MONROE COUNTY DRAINAGE BOARD
Wednesday December 6, 2023, at 8:30 AM
Location: Showers Building Room 106D
Hybrid Meeting with Virtual Attendance via Zoom

Project Name: North Park Area B-9
Engineer/Design Firm: Daniel Butler, Bynum Fanyo
Address: SW of SR 46 and I-69
Acres: 28 acres disturbed/98.6 acres

North Park Area B-9 Fill Site – Drainage Comments**Sinkholes, Sinking Streams, and Karst Springs:**

title: Overall Grading Plan

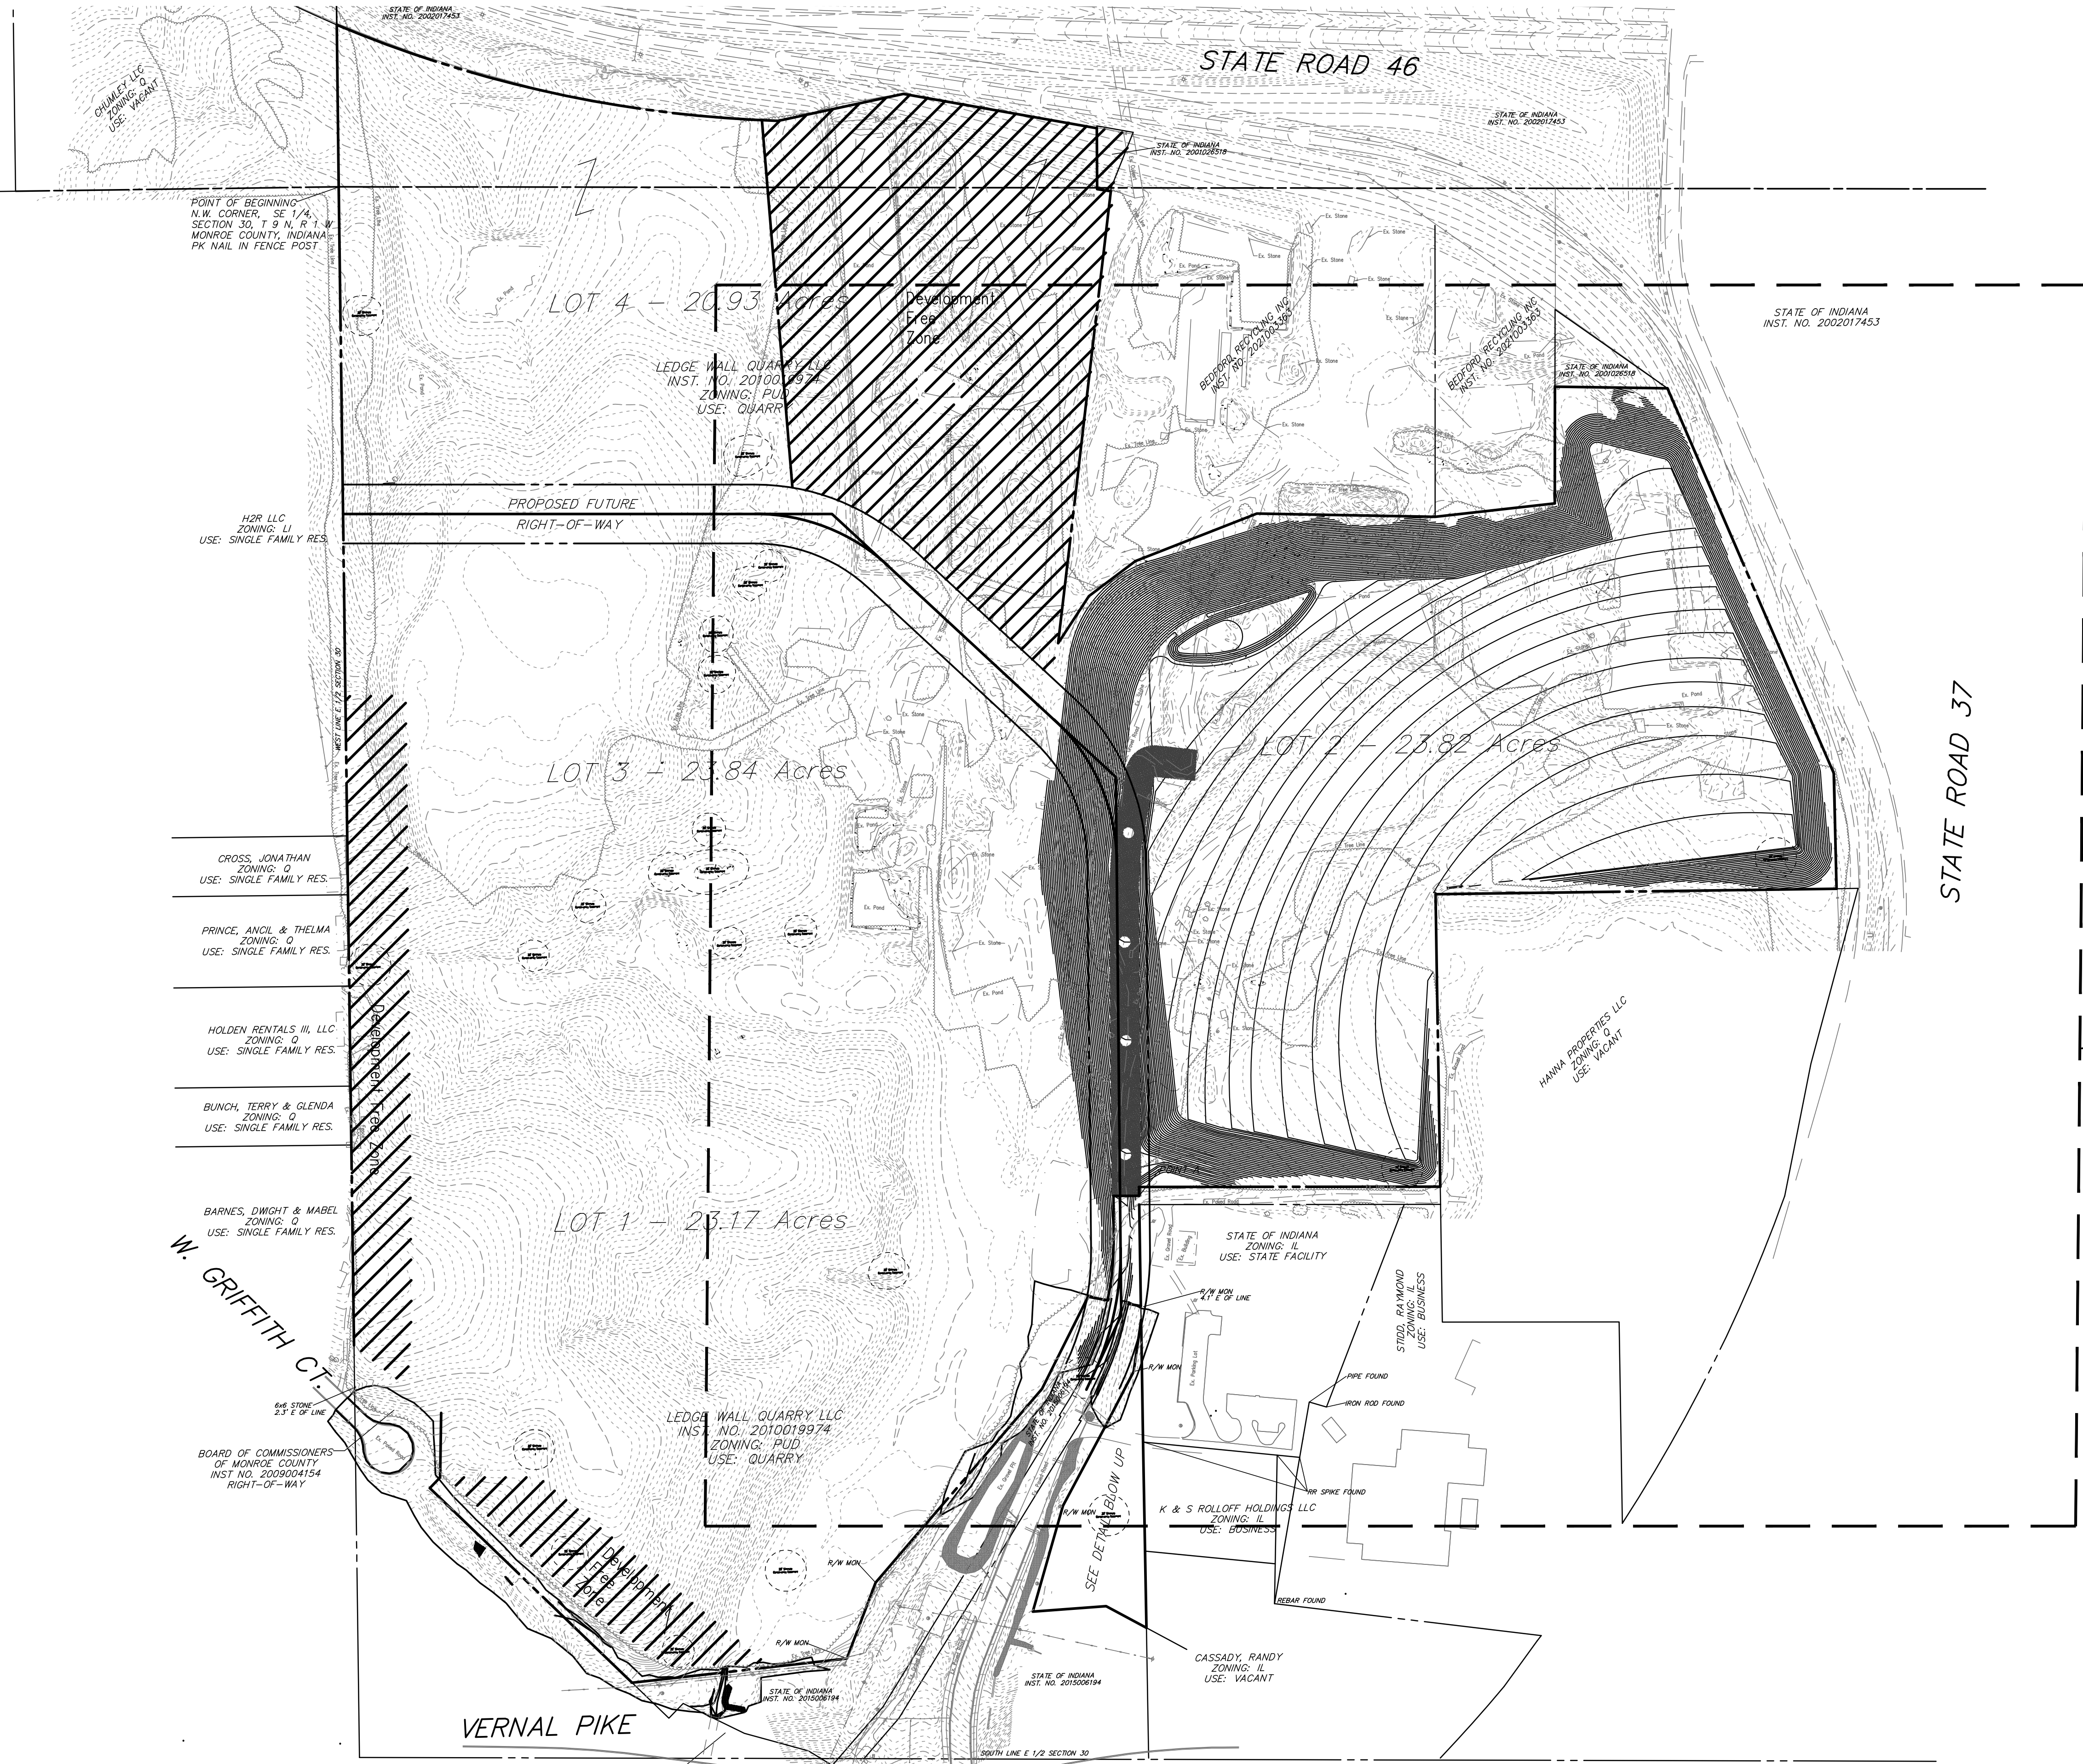
- I have concerns about the fill area over identified karst features:
 - Driveway crosses SP-04, a karst spring.
 - Fill area covers SP-03, a karst spring.
 - Fill area covers SS-01, a sinking stream.
- SCAs noted on the plans should specify the types of karst features where there are proposed impacts. This information is available in your karst report.
- No karst features should be impacted as part of these fill operations.
 - Please revise plans to show that SS-01 and SP-03 are avoided and their drainage areas protected.
 - If SP-04 will be impacted due to its proximity to the existing driveway, please show plans for mitigation (what will you do with the water from the spring?) and ideally, this should be communicated to Jason Krothe so he can provide input on appropriate mitigation strategies.

- The proposed temporary sediment basin is shown roughly 40 feet above existing grade. This is fine for later fill operations, but I need to see a plan for temporary sediment traps to be installed prior to any fill operations beginning. Since this will be a large long-term operation, there should be sediment traps along the toe of the slope to capture erosion from the fill area during different phases of the project.
- Provide benches along the slope in the final grading plan.
- Silt fence is not an adequate practice to capture runoff from a 30-40 ft 3:1 slope. Pipe slope drains may be a good practice to convey water from the top of the pile to sediment traps at the toe of the slope.
- Provide drainage calculations showing the capacity/adequacy of the sediment traps.
